Access Compliance Report

Public Rights-of-Way

(Curb Ramps)

Intersection ID: 10018683	Main Street: KARAM_LN	Cross Street: N/A	Location: E
ADA ID: CD9700200660	Ramp Type: Perp	Initial Pass/Fail: Fail	Overall Compliance: No
Severity Score: 10			
Codes/Mitigation Info/Possible Solution		Field Measurements/Component Compliance

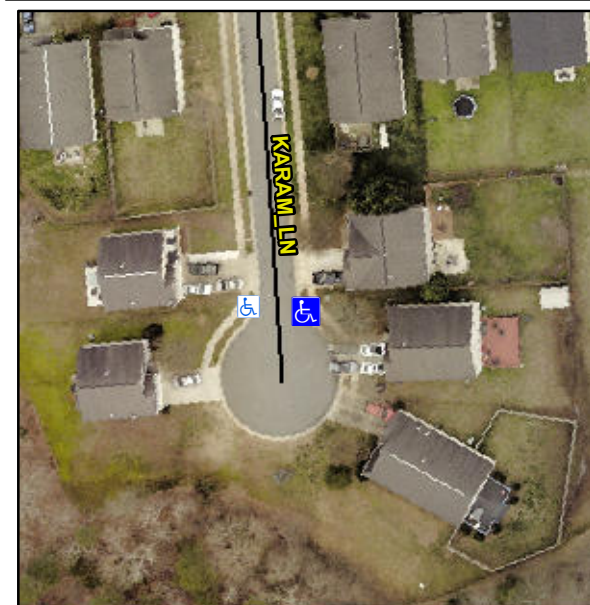
Not Found, R304.5.1

Compliance	Description	Data	Compliance	Description	Data
N/A	Ramp Length (in)	47.5	Yes	Ramp Slope (%)	7.1
No	Ramp Width (in)	43.5	Yes	Ramp XSlope (%)	2.1
N/A	Flare Type LT	N/A	N/A	Flare Type RT	N/A
N/A	Flare Slope LT (%)	N/A	N/A	Flare Slope RT (%)	N/A
N/A	Flare Traversable LT?	N/A	N/A	Flare Traversable RT?	N/A
N/A	Landing Length (in)	N/A	N/A	DWS Provided?	N/A
N/A	Landing Width (in)	N/A	N/A	DWS Contrast?	N/A
N/A	Landing Slope (%)	N/A	N/A	DWS Length (in)	N/A
N/A	Landing X Slope (%)	N/A	N/A	DWS Full Width?	N/A
N/A	Landing Curb? (Y/N)	N/A	N/A	DWS Offset (in)	N/A
N/A	Shared Landing?	N/A			
N/A	Gutter Ponding?	N/A	N/A	Gutter Slope (%)	N/A
N/A	Gutter Lip Ht (in)	N/A	N/A	Gutter X Slope (%)	N/A
N/A	Painted X Walk1?	No	N/A	Painted X Walk2?	N/A
	X Walk 1 Direction	To W		X Walk 2 Direction	N/A
N/A	X Walk 1 Width (in)	N/A	N/A	X Walk 2 Width (in)	N/A
	X Walk 1 Slope (%)	2.3		X Walk 2 Slope (%)	N/A
	X Walk 1 X Slope (%)	3.1		X Walk 2 X Slope (%)	N/A

Remove & Replace Entire Ramp.
